# Access Compliance Report

## Public Rights-of-Way

Intersection ID: 9668	Main Street: THE_PLAZA	Cross Street: VICKERY_DR	Location: SE
ADA ID: 7C8EB6170C7E	Ramp Type: Perp	Initial Pass/Fail: Fail	Overall Compliance: No
Severity Score: 13.75			
Codes/Mitigation Info/Possible Solution		Field Measurements/Component Compliance

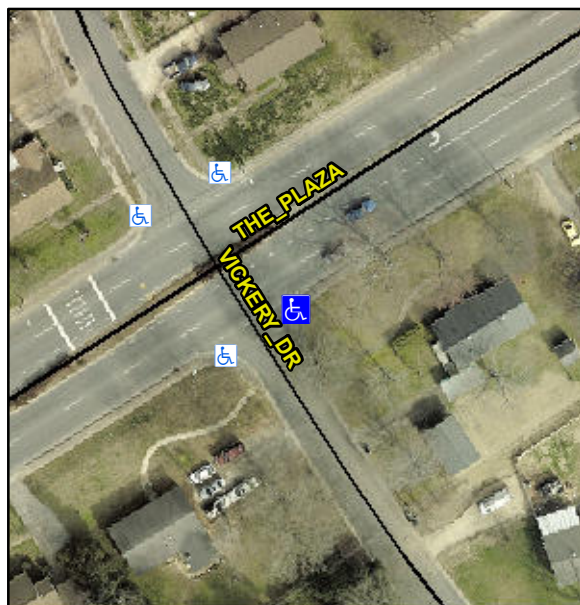
**Not Found, R304.2.2, R304.5.3**

Compliance	Description	Data	Compliance	Description	Data
N/A	Ramp Length (in)	60.5	No	Ramp Slope (%)	10.5
Yes	Ramp Width (in)	48.0	No	Ramp XSlope (%)	3.0
N/A	Flare Type LT	N/A	N/A	Flare Type RT	N/A
N/A	Flare Slope LT (%)	N/A	N/A	Flare Slope RT (%)	N/A
N/A	Flare Traversable LT?	N/A	N/A	Flare Traversable RT?	N/A
N/A	Landing Length (in)	N/A	N/A	DWS Provided?	N/A
N/A	Landing Width (in)	N/A	N/A	DWS Contrast?	N/A
N/A	Landing Slope (%)	N/A	N/A	DWS Length (in)	N/A
N/A	Landing X Slope (%)	N/A	N/A	DWS Full Width?	N/A
N/A	Landing Curb? (Y/N)	N/A	N/A	DWS Offset (in)	N/A
N/A	Shared Landing?	N/A			
N/A	Gutter Ponding?	Yes	N/A	Gutter Slope (%)	N/A
N/A	Gutter Lip Ht (in)	N/A	N/A	Gutter X Slope (%)	N/A
N/A	Painted X Walk1?	No	N/A	Painted X Walk2?	N/A
	X Walk 1 Direction	To SW		X Walk 2 Direction	N/A
N/A	X Walk 1 Width (in)	N/A	N/A	X Walk 2 Width (in)	N/A
	X Walk 1 Slope (%)	1.8		X Walk 2 Slope (%)	N/A
	X Walk 1 X Slope (%)	0.2		X Walk 2 X Slope (%)	N/A

**Remove & Replace Entire Ramp.**
